**SUBJECT: James A. FitzPatrick Nuclear Power Plant
Docket No. 50-333
Response To NRC Request for Additional Information
Regarding FitzPatrick's Proposed Exemption Request
For Hemyc Fire Wrap (TAC No. MC7995)**

Attachment 1 to JAFP-06-0079
Entergy Nuclear Operations, Inc. – FitzPatrick
Docket No. 50-333
Response to Request for Additional Information (RAI)

Page 1 of 4
(Pull Box Photographs)

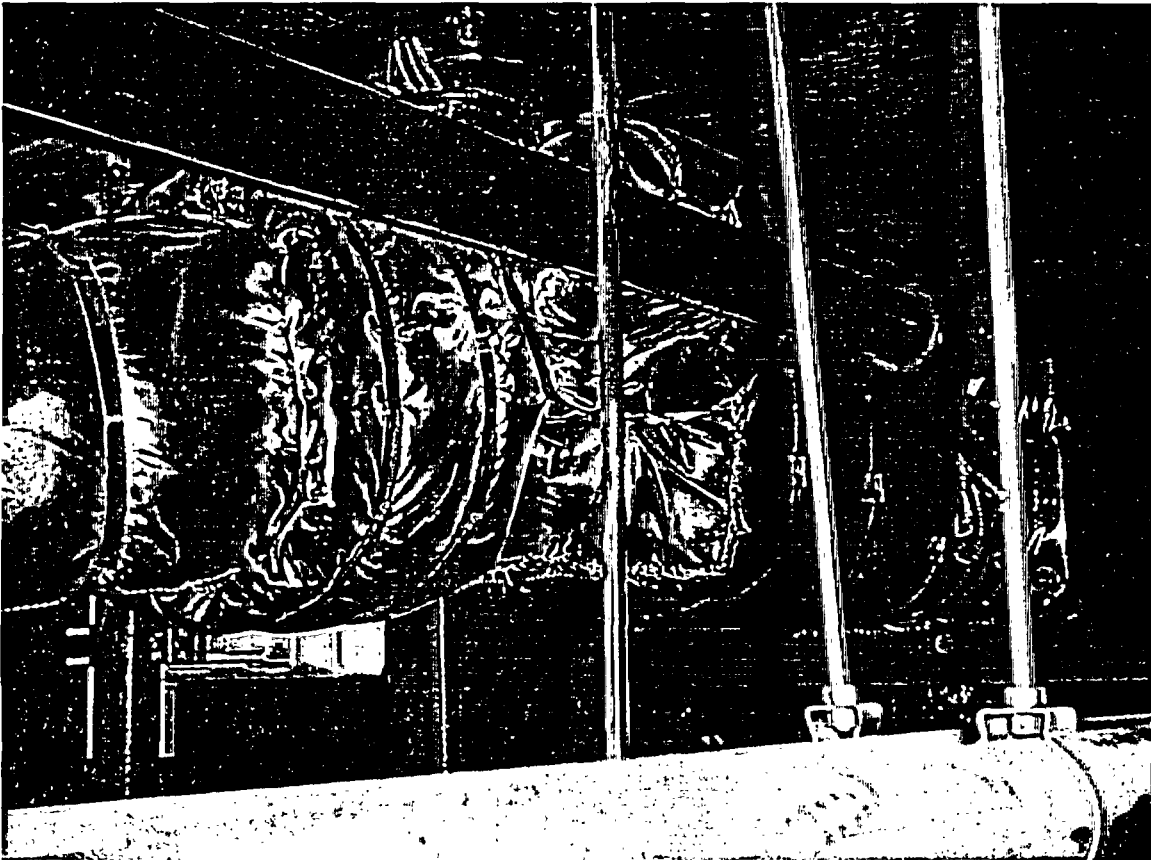
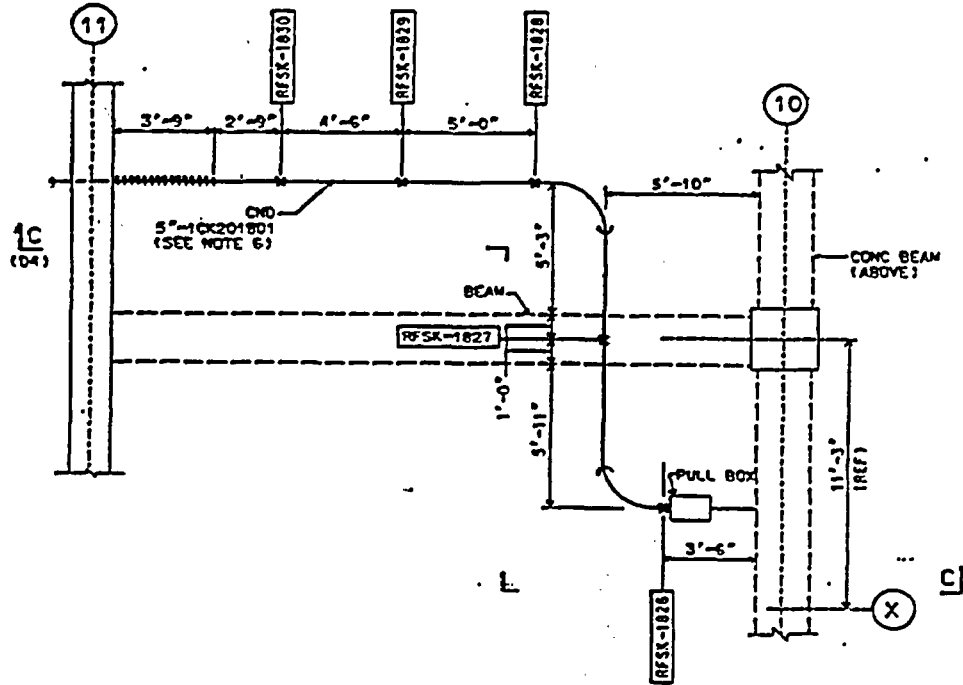
On page 2 of the licensee's submittal, the last paragraph states that the testing performed by the NRC supports the expectation that the installed configuration at FitzPatrick will meet or exceed a 30-minute fire rating. Although the NRC test results for a 4-inch conduit indicate failure as early as 33 minutes following the onset of a fire, when empty, and 43 minutes when full; other components of the raceway failed in less than 30 minutes. The unbanded junction boxes failed as early as 15 minutes into the event. The FitzPatrick configuration includes a pull box with stitched end pieces that are not banded. These end pieces, which could fail similarly to the stitched portion of the unbanded junction box that failed during the NRC test, are described as being secured by conduit wrap butted against them. Please provide a photograph or drawing of this pull box configuration, illustrating the security added at the end pieces. Also, please describe in detail the rationale for the statement that failure of these end pieces "is not expected to heat up the pull box to the point it would cause the cable to fail."

The banded junction box configurations tested by the NRC are somewhat different than the Hemyc wrapped pull box configuration present at JAF. The pull box is wrapped in manner that is better compared to the actual conduit or condulets tested versus the large junction boxes tested by the NRC. As seen in Attachment 2, the pull box at JAF is wrapped with a single piece of Hemyc, similar to a conduit, with stitched in place end pieces. The end pieces are partially secured in place with the Hemyc that is wrapped around the conduit. This configuration would prevent the end pieces from falling away even if the stitching of the end pieces were to fail. The un-banded junction boxes tested by the NRC had no attachments (i.e. Hemyc wrapped conduit) to the junction boxes, therefore, there were no items to prevent the wrap from falling away once the material shrunk and the stitching failed. Because the pull box at JAF has the 5 inch conduit protruding from both ends the actual area of the exposed end pieces is minimal as seen in the photographs (Attachment 2). The Hemyc on the pull box also has enough excess material such that if minimal shrinkage did occur the stitched joints would not fail.

The primary reason the stitched seam junction box tested by the NRC failed in less than 30 minutes can be attributed to the fact that the material contracted which caused the stitching to fail and subsequently the material pulled away causing direct flame impingement on the junction box. The banded junction box tested by the NRC did not fail until the 31 minute mark because the Hemyc was maintained in place for a longer period of time. In addition, the 31 minute failure was measured on the outside of the junction box (cold side of fire barrier), therefore, it is reasonable to assume the internal pull box temperature would be below the failure point of the cable beyond the 31 minute mark.

Additional industry testing on conduits using Hemyc made from actual Siltemp did not experience the same degree of thermal shrink as the Refrasil tested by the NRC. This new test information shows that the Hemyc material on the pull box will not shrink substantially enough to cause the stitched joints to fail. Additionally, the aluminized Siltemp used at JAF has better thermal reflectivity than conventional Siltemp. The improved reflectivity ensures the pull box is sufficiently wrapped to provide a 30 minute fire rating. In addition, there are no plausible fire hazards in the area of the pull box (Reference 4) that would subject it to a fire similar to what was tested. The presence of automatic full area suppression, in tray suppression, and full area detection further ensure the potential for an unmitigated fire is non-existent.

The information above validates the statement that the pull box is not expected to heat up to the point where the cable would fail based on a short circuit temperature of 482°F for the internal cables as previously discussed in the exemption request (Reference 2).

PART PLAN B
TURBINE BUILDING ELECTRIC TUNNEL EL 260'-0"
DWG #FE-45E
1/4"=1'-0"

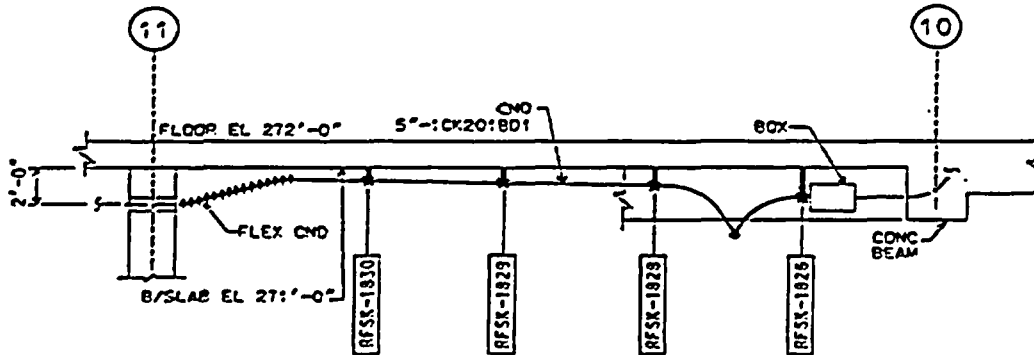
The submittal describes Hemyc wrapped structural supports. Steel supports were tested by the NRC separately from the conduit and found to fail as early as 13 minutes into the event. The additional heat load transferred to the conduit by the steel supports was not considered in the conduit tests. The FitzPatrick configuration is described as including five structural supports, completely wrapped except for a portion of the base plate. How has it been determined that the heat transfer from the exposed base plate would not adversely affect the protected cable? In the event of a fire, what would be the impact of heat transfer from the uncovered base plate through the supports to the conduit? In responding to these questions, please include the distance from the baseplate to the conduit containing the cable, and quantify the distance into an hourly rating using the NRC testing for similar supporting structures (angle iron, unistrut). Please also include the area of the base plate that is uncovered.

The effects of heat transfer from the exposed base plate have been evaluated based on a comparison of the JAF structural support configuration with the results of testing performed by the NRC, and engineering judgment.

The JAF structural support configuration utilizes multiple pieces of unistrut horizontally mounted to steel spacers. The spacers consist of square tube steel, steel plate, or "C" channel mounted to base plates which are mounted to a concrete ceiling with Hilti Kwik Bolt II anchor bolts. The steel support members attached to the base plates are entirely wrapped with Hemyc which results in most of the base plate being covered. The area of the base plates that is uncovered

varies, but is roughly the outer 2 inches on either end of the 6 inch by 12 inch plates, and roughly the outer 2 ½ inches on the exposed perpendicular edges and approximately 5 inches exposed at the corners of the 12 inch by 12 inch plate. The distance between the uncovered base plate and the conduit containing the cable is just over 5" for the limiting case. This was determined for support RFSK-1827, considering a linear distance from the uncovered base plate, across the wrapped portion of the base plate, the solid steel spacers, the double unistrut to the point where the conduit with the cable makes contact with the unistrut. See Attachments 3 through 8 for diagrams and photographs of the Hemyc wrapped supports.

Page 1 of 3
(Support RFSK-1826 Diagram and Photographs)

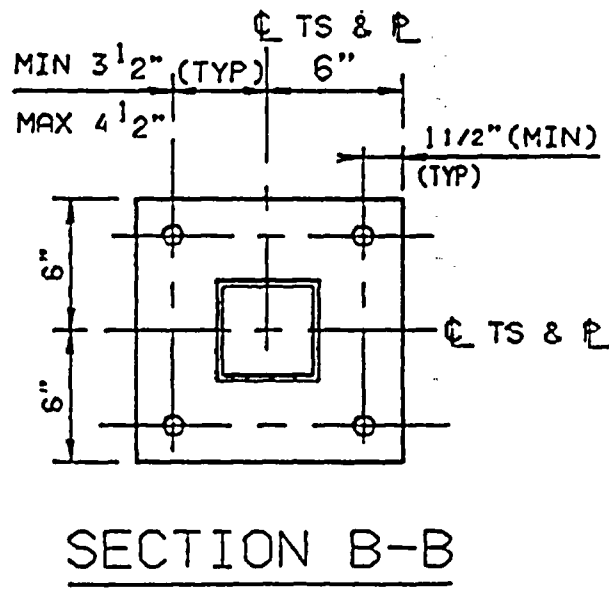
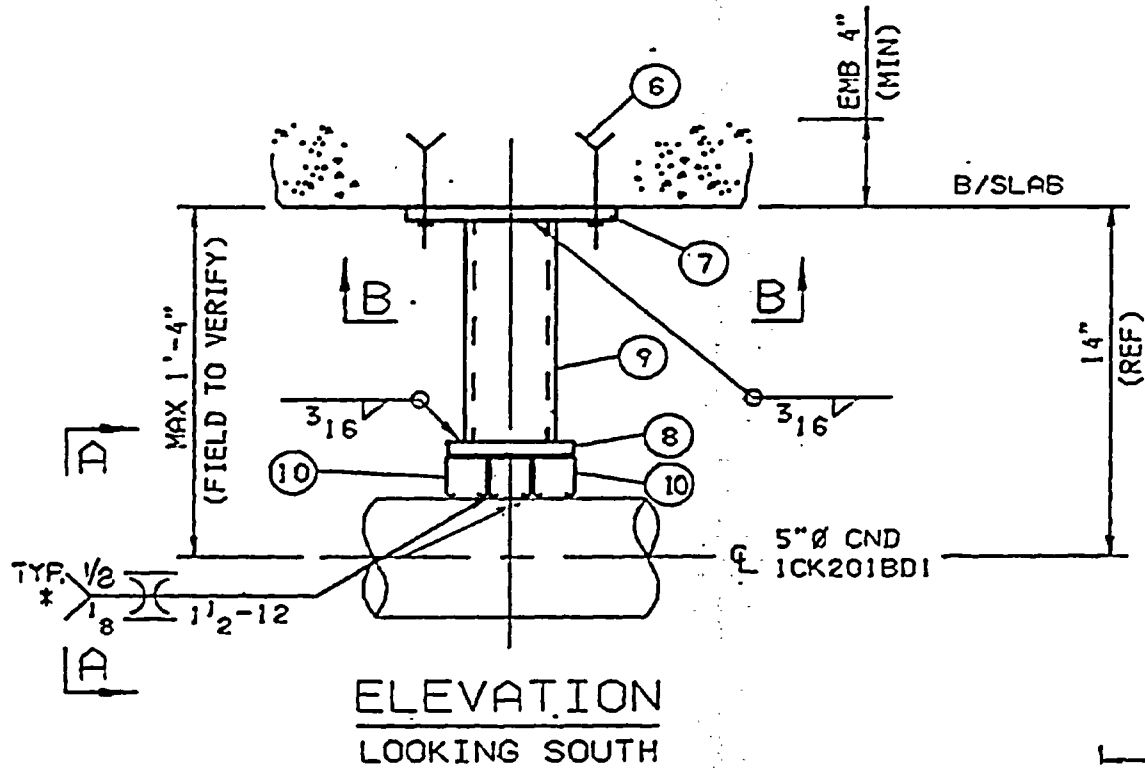
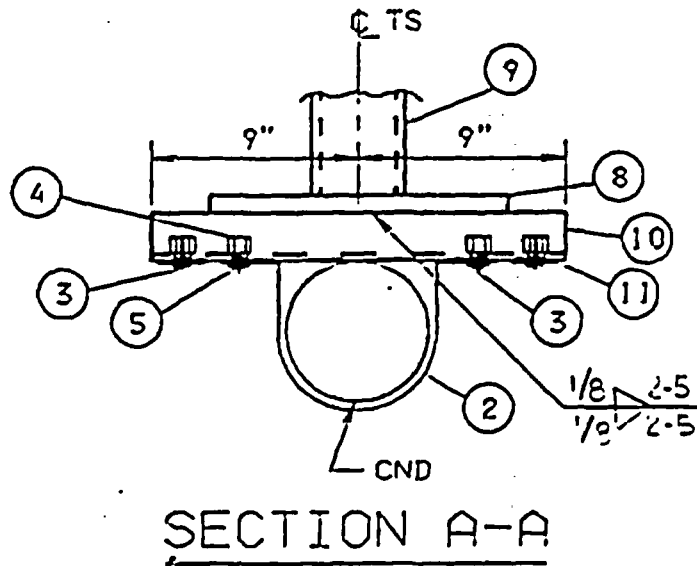
The structural support base plates are described as mounted in place with Hilti bolts to the concrete ceiling. Are these bolts covered by fire wrap? In the event of an intense fire, could concrete spalling compromise the ability of these bolts to function? If not, why not?

The Hilti Kwik Bolt II bolts used to secure the structural supports in place are not entirely covered by the Hemyc fire wrap as seen in the attached photographs. At the time the Hemyc wrap was installed, the need to wrap the base plates and Hilti bolts was evaluated using the guidance contained in NRC Generic Letter 86-10 (Reference 6) and it was determined that wrap was not required.
